STAFF RECOMMENDATION
1309 Woodland Street
June 19, 2019

Application: New Construction—Outbuilding/Detached Accessory Dwelling Unit
District: Lockeland Springs-East End Neighborhood Conservation Zoning Overlay
Council District: 06
Base Zoning: R6
Map and Parcel Number: 08309015600
Applicant: L. Lesley Beeman, Manuel Zeitlin Architects
Project Lead: Melissa Baldock, melissa.baldock@nashville.gov

1 SITE PLAN
1" = 10'-0"

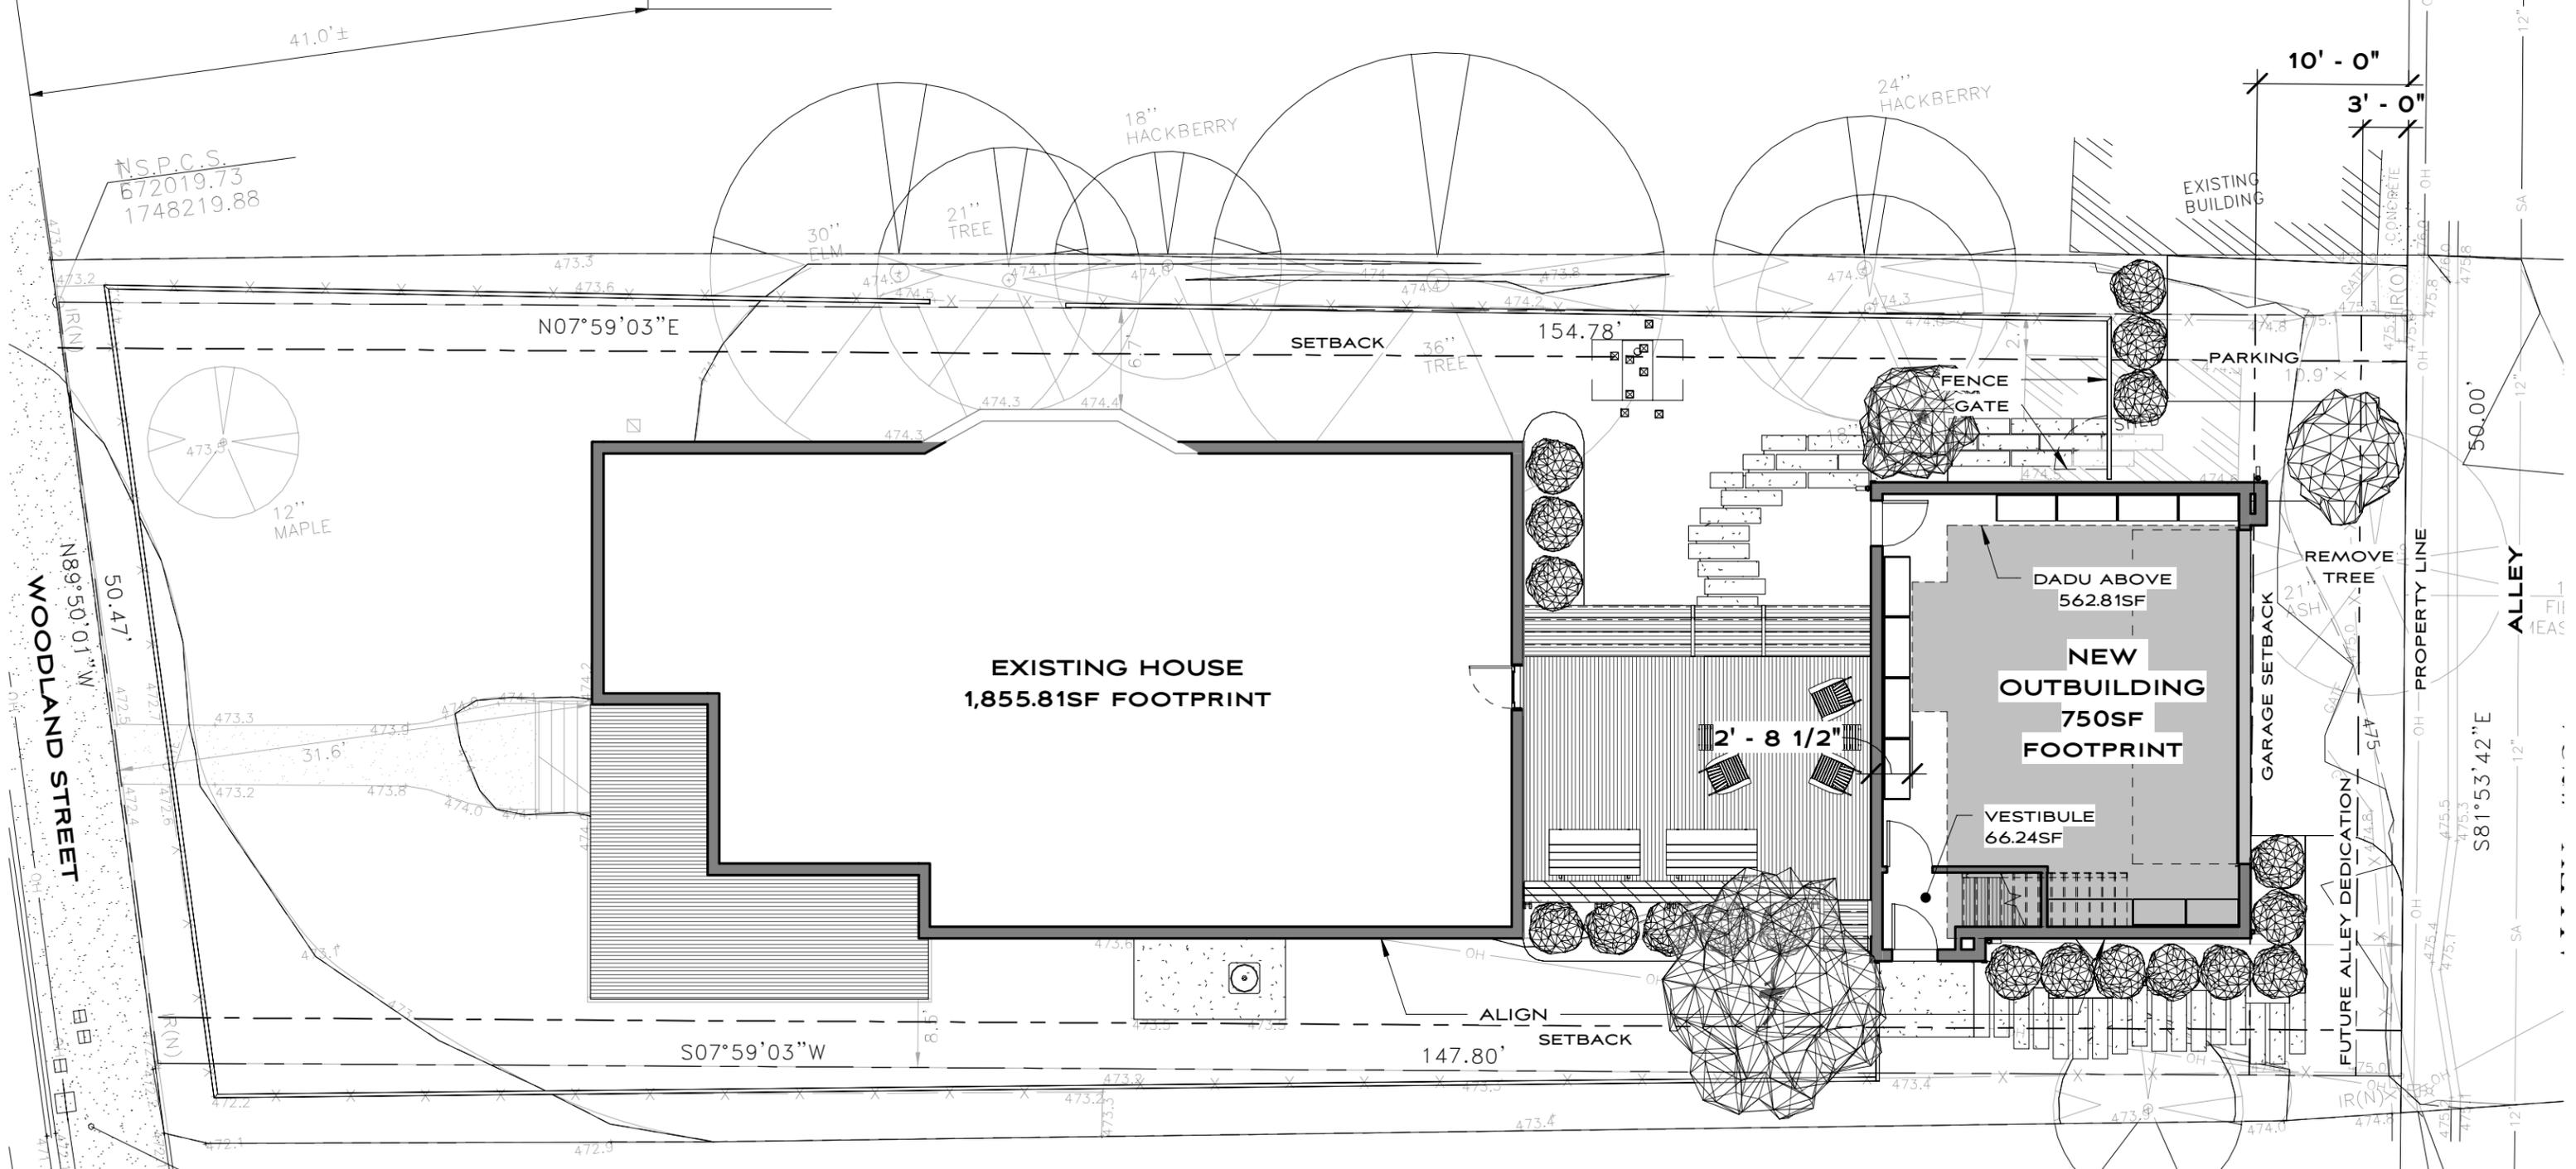
Site Planning & Setbacks: The proposed outbuilding will be larger than seven hundred square feet (700 sq. ft) in footprint. For outbuilding with a footprint of larger than seven hundred square feet (700sqft), the setback requirements are as follows:

Staff finds that the DADU's location and setbacks meet the design guidelines and the DADU ordinance.

DRISCOLL RES GARAGE
BUILDING ELEVATIONS
HISTORIC SUBMITTAL **H3**
MAY 30, 2019 1924
MANUEL ZEITLIN ARCHITECTS

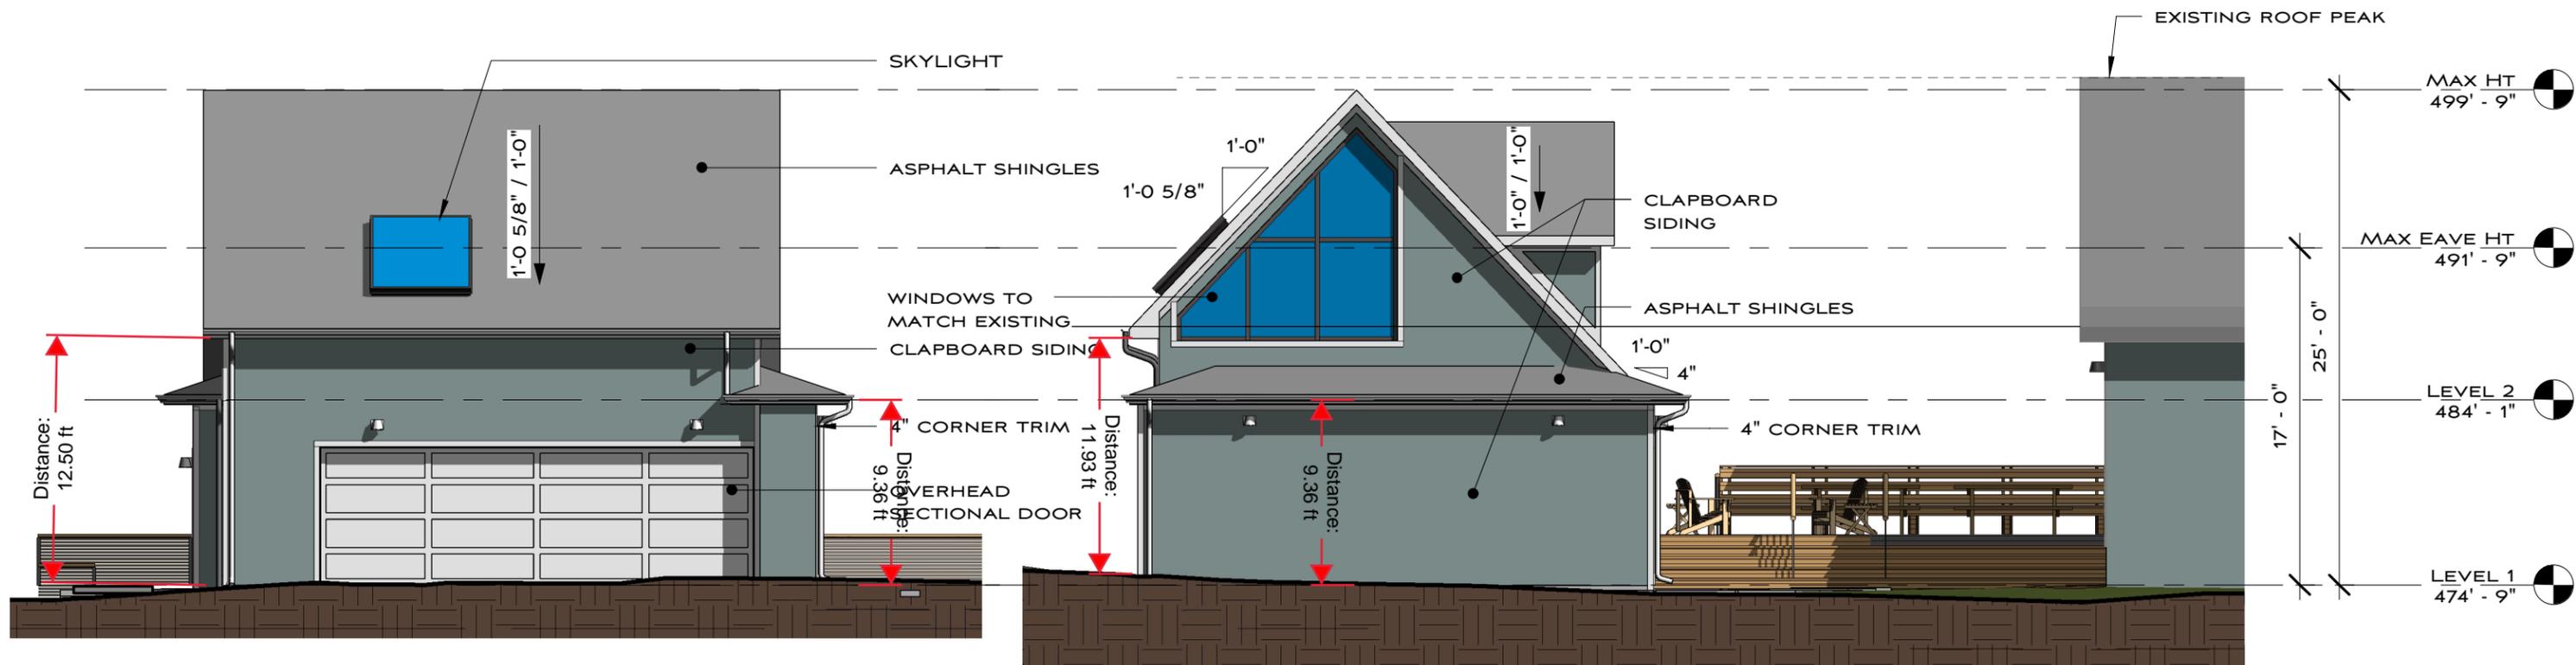
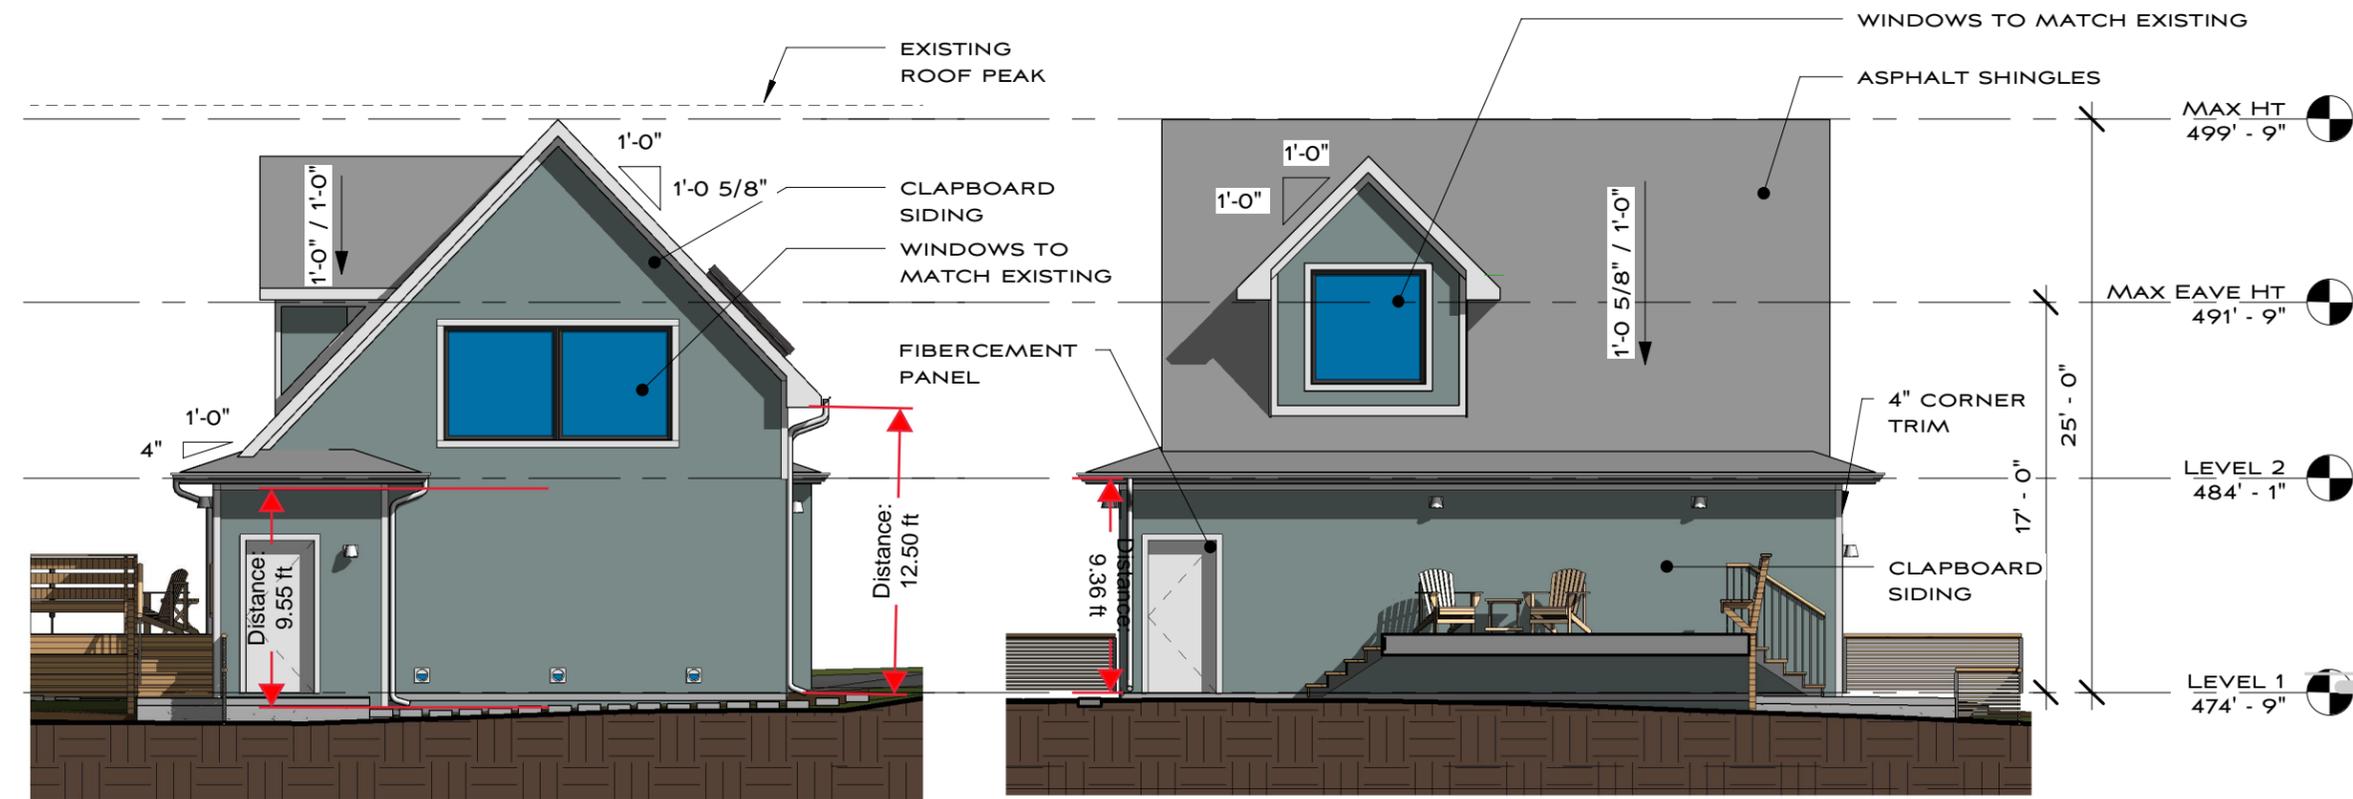
In this case, the applicant is proposing a structure with eave heights along the alley that are over twelve feet (12'), which exceeds the ten foot (10') limit called out in the DADU ordinance.

MHZC measures footprints of DADUs from exterior wall to exterior wall. In this case, the footprint of the DADU is slightly larger than the seven hundred and fifty square feet (750 sq. ft.) which is the maximum allowed under the DADU ordinance and the design guidelines.

Staff recommends that the eave heights be no taller than ten feet (10').

Staff recommends that the footprint be reduced to be no larger than seven hundred and fifty square feet (750 sq. ft.) when measured from exterior wall to exterior wall.

1. All eave heights be no taller than ten feet (10’);
2. The footprint of the structure, as measured from exterior wall to exterior wall, be no greater than seven hundred and fifty (750 sq. ft);
3. The lap siding have a maximum reveal of five inches (5’); and
4. Staff approve all windows and doors and the roof shingle color prior to purchase and installation.
